Access Compliance Report

Public Rights-of-Way

(Curb Ramps)

Intersection ID: 45164	Main Street: ELESSAR_PL	Cross Street: ARAGORN_LN	Location: E
ADA ID: E747CF0BAEEF	Ramp Type: PerpDiag	Initial Pass/Fail: Fail	Overall Compliance: No
Severity Score: 8.75			
Codes/Mitigation Info/Possible Solution		Field Measurements/Component Compliance

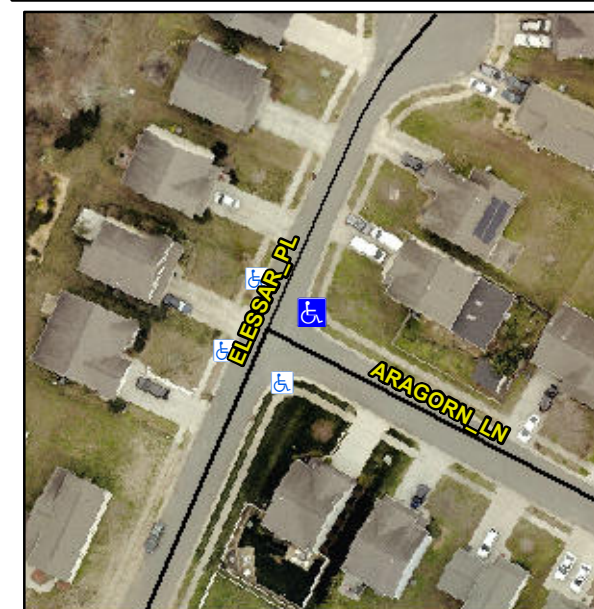
Not Found, R304.5.1

Compliance	Description	Data	Compliance	Description	Data
N/A	Ramp Length (in)	48.0	Yes	Ramp Slope (%)	7.3
No	Ramp Width (in)	43.0	Yes	Ramp XSlope (%)	0.9
N/A	Flare Type LT	N/A	N/A	Flare Type RT	N/A
N/A	Flare Slope LT (%)	N/A	N/A	Flare Slope RT (%)	N/A
N/A	Flare Traversable LT?	N/A	N/A	Flare Traversable RT?	N/A
N/A	Landing Length (in)	N/A	N/A	DWS Provided?	N/A
N/A	Landing Width (in)	N/A	N/A	DWS Contrast?	N/A
N/A	Landing Slope (%)	N/A	N/A	DWS Length (in)	N/A
N/A	Landing X Slope (%)	N/A	N/A	DWS Full Width?	N/A
N/A	Landing Curb? (Y/N)	N/A	N/A	DWS Offset (in)	N/A
N/A	Shared Landing?	N/A			
N/A	Gutter Ponding?	N/A	N/A	Gutter Slope (%)	N/A
N/A	Gutter Lip Ht (in)	N/A	N/A	Gutter X Slope (%)	N/A
N/A	Painted X Walk1?	No	N/A	Painted X Walk2?	No
	X Walk 1 Direction	To NW		X Walk 2 Direction	To SW
N/A	X Walk 1 Width (in)	N/A	N/A	X Walk 2 Width (in)	N/A
	X Walk 1 Slope (%)	2.8		X Walk 2 Slope (%)	3.2
	X Walk 1 X Slope (%)	3.9		X Walk 2 X Slope (%)	5.8

Remove & Replace Curb Ramp With Two New Directional Ramps or Equivalent.
